# Technical Service Bulletin

## 43 Air suspension system fault - DTC C118D01 Compressor for level control electrical error

43 24 90 2073034/5 May 14, 2024. Supersedes Technical Service Bulletin Group 43 number 24-88 dated May 7, 2024 for reasons listed below.

**Figure 1.** Verify that the compressor electronics is part number 4M0.907.778.A.

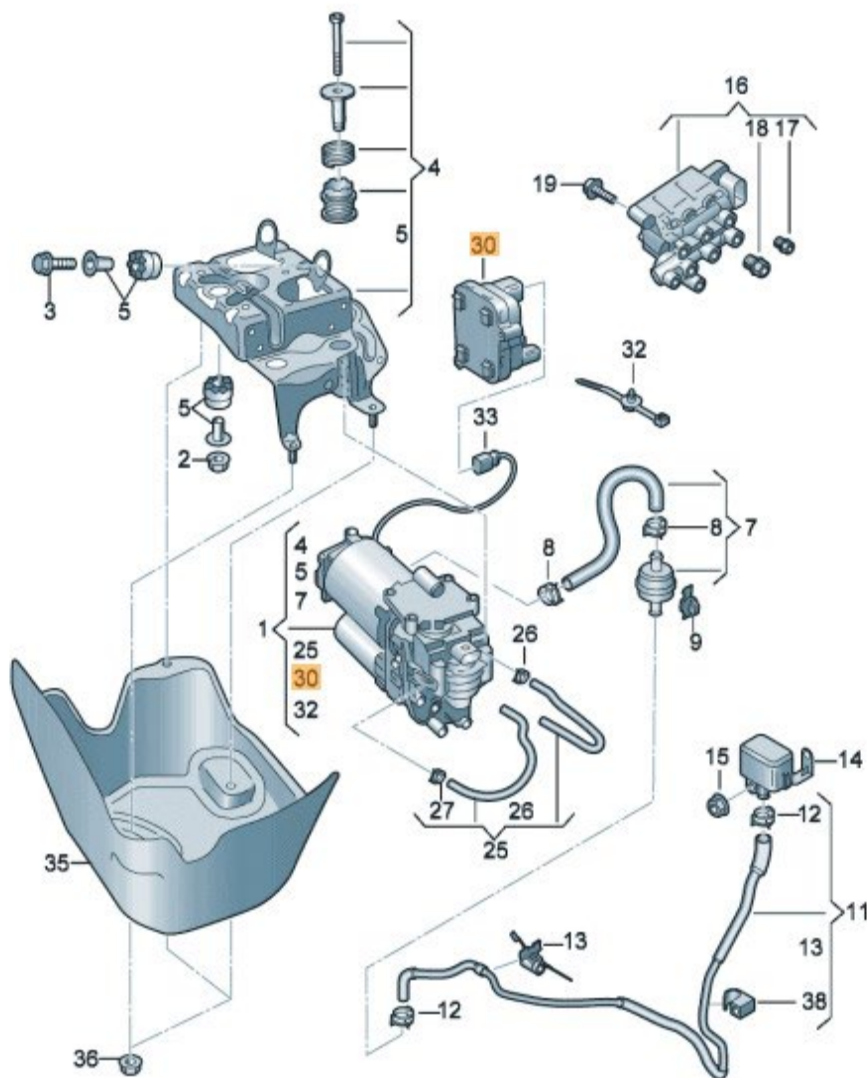
The described procedure only applies if compressor electronics with part number index A are fitted in the vehicle (affected part number 4M0.907.778.A) (Figure 1, number 30).

- If the DTC is **passive/intermittent**, delete the DTC.
- If the DTC is logged as **active/static** and remains active/static after the ignition is switched off and then on again, replace the control unit for compressor electronics J1135 (**not the air compressor**).
- Please use part number **4M0.907.778 (Without index A)**.
